## Agenda Item # 5

### SUB-003525-2025

Coffman – Turner Subdivision

## COFFMAN - TURNER SUBDIVISION

## DETAIL SITE PLAN

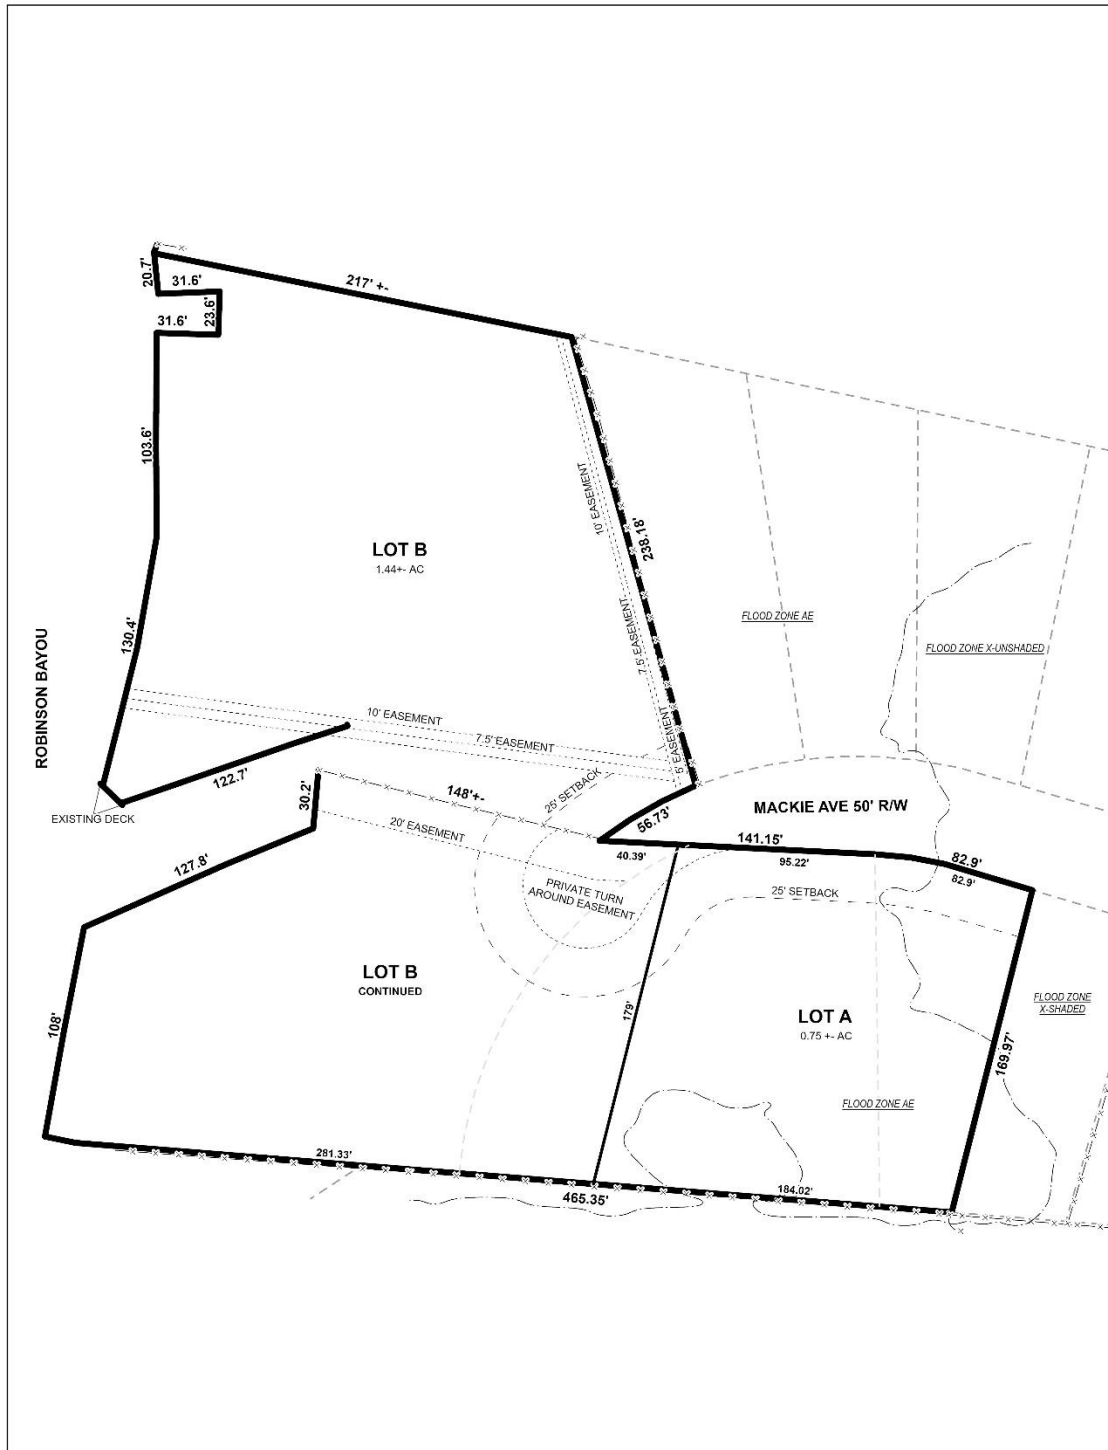
- B. Provide a written description for the proposed subdivision boundary. Make sure to include the western boundary of the subdivision since it is not shown or labeled with bearings and distances or reference ties.

- C. Provide (by dedication) a full 50' wide ROW to the end of Mackie Ave.
- D. Provide an adequate public turnaround at the west end of Mackie Ave.
- E. National Wetlands Inventory (NWI) mapping, as shown on City of Mobile GIS information, indicates that there is potential for wetlands within the property or properties shown on this plat. Show and label the delineated wetlands or provide a note stating that the wetlands shown on this plat are scaled from the NWI data and have not been delineated.

- G. Show and label the MFFE (Minimum Finished Floor Elevation) on each lot that contains an A, AE, or X (shaded) flood zone designation. BFE = 11.
- H. Retain NOTES 7 – 9, 13, and 15.

- I. Revise NOTE 16 to read “As shown on the 1984 aerial photo LOTS A and B will receive historical credit of existing (1984) impervious area towards stormwater detention requirement per Mobile City Code, Chapter 17, Storm Water Management and Flood Control) as follows: LOT 1 – NONE and LOT 2 – NONE. Stormwater detention will be required for any additional impervious area on either LOT over 4,000 SF.

The site has frontage on Mackie Avenue, a minor street without curb and gutter and a substandard 50-foot right-of-way, and requiring a 60-foot right-of-way. Therefore, dedication should be required to provide 30 feet from the centerline of Mackie Avenue along that street frontage. The preliminary plat indicates an existing private turn-around easement at the West terminus of Mackie Avenue within the subject site. As this is actually a physical extension of Mackie Avenue, this area should be dedicated to the City of Mobile, with revision of the cul-de-sac diameter to comply with International Fire Code Standards, and as determined by the City Engineer per Section 6.B.9. of the Subdivision Regulations.

The preliminary plat illustrates the 25-foot minimum building setback line along Mackie Avenue as measured from the current right-of-way line. The plat should be revised to illustrate the 25-foot minimum building setback line as measured from any required frontage dedication, including the cul-de-sac radius dedication. The lot size labels in both square feet and acres should be retained on the Final Plat, if approved, adjusted for any required dedication, or a table should be furnished on the Final Plat providing the same information.

As proposed, Lot 7-A would exceed the depth-to-width ratio of Section 6.C.3. of the Subdivision Regulations and would require a waiver of that section, if approved.

The preliminary plat illustrates various drainage, sanitary sewer, and utility easements within the site. These should be retained on the Final Plat, if approved, and a note should be furnished on the Final Plat stating that no structure shall be constructed or placed within any easement without the permission of the easement holder.

1. Dedication to provide 30 feet from the centerline of Mackie Avenue;
2. Dedication of the private easement cul-de-sac to the City of Mobile, as determined by the City Engineer;
3. Revision of the plat to illustrate the 25-foot minimum building setback line along Mackie Avenue and the cul-de-sac as measured from any required dedication;
